STAFF REPORT: 12/13/2023 REGULAR MEETING

APPLICATION NUMBER: HDC2023-00136

ADDRESS: 3627 LINCOLN

SCOPE: ERECT THREE-CAR GARAGE, REMOVE FENCE

Figure 1, by Applicant: showing alley (west) side elevation of the proposed garage.

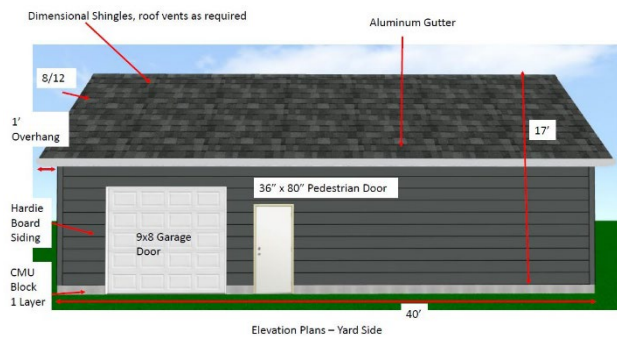
- Staff offers the opinion that the pitch and height of the roof, design, scope, and materials of the garage are appropriate and closely aligns with the Elements of Design.
